TD AMERITRADE  
BRENTWOOD

Quality Custom Cabinets

APPROVED AS NOTED  
By Katie Kelchner at 3:11 pm, 12/10/09

Subject: SUBMITTAL SDE  
Date: 11-20-09  
12-03-09  
Project Manager: CHRIS BROOKS

**A**  
17  
SINAGE PLAN SECTION  
3/4" = 1'-0"  
REF: N/A

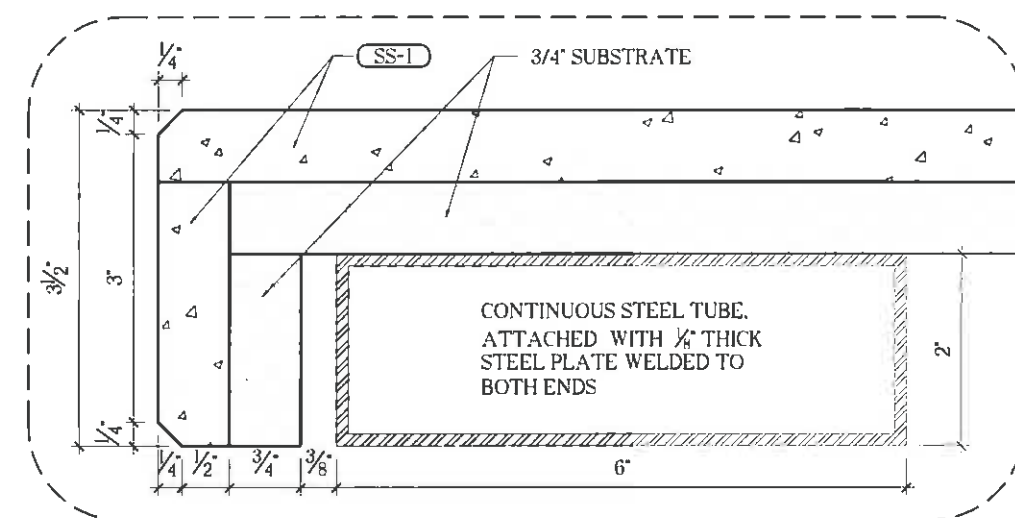
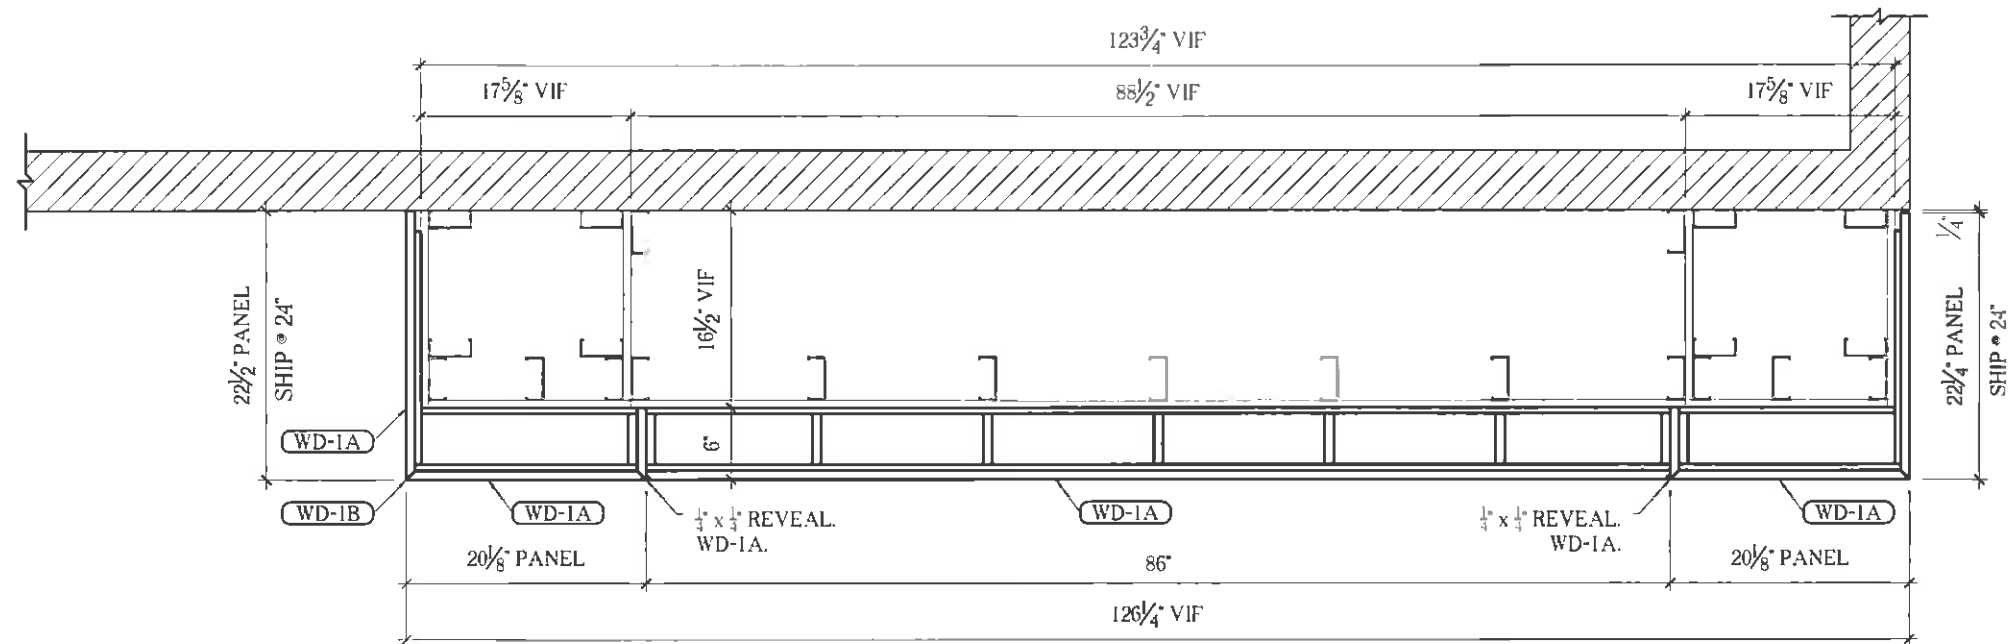
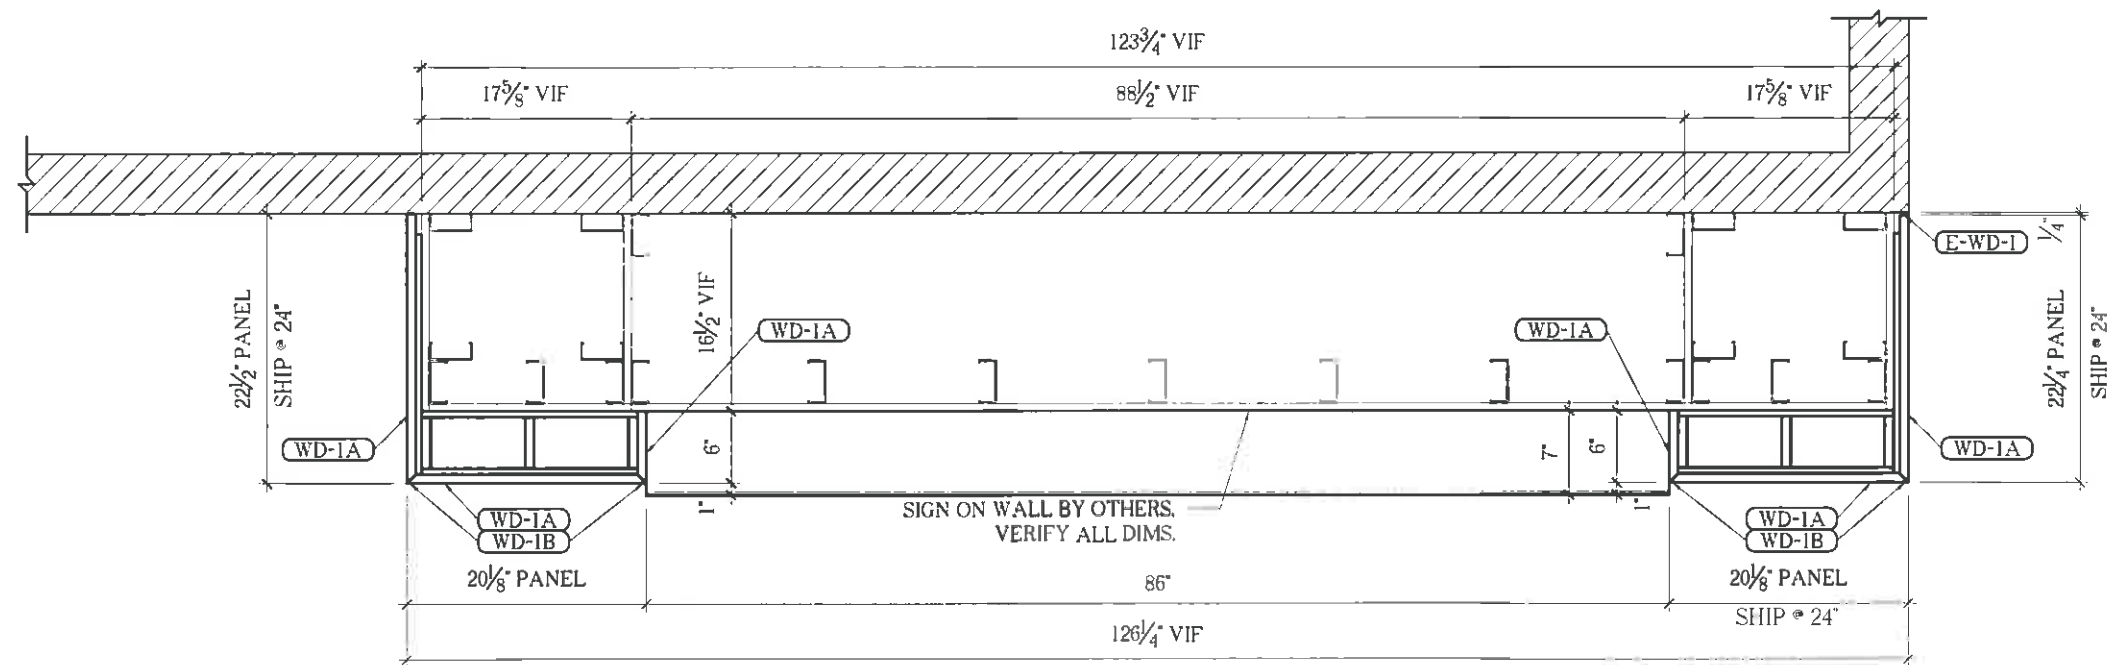
ARCHITECT NOTE:  
IN ORDER TO HAVE (2) FILE  
DRAWERS WE NEED THE  
DRAWER FRONTS TO BE 13". IN  
ORDER TO ACHIEVE THIS WE  
NEED TO EITHER RAISE THE  
COUNTER OR LOWER THE TOE  
KICK. I HAVE LOWERED THE  
TOE KICK BUT PLEASE ADVISE.
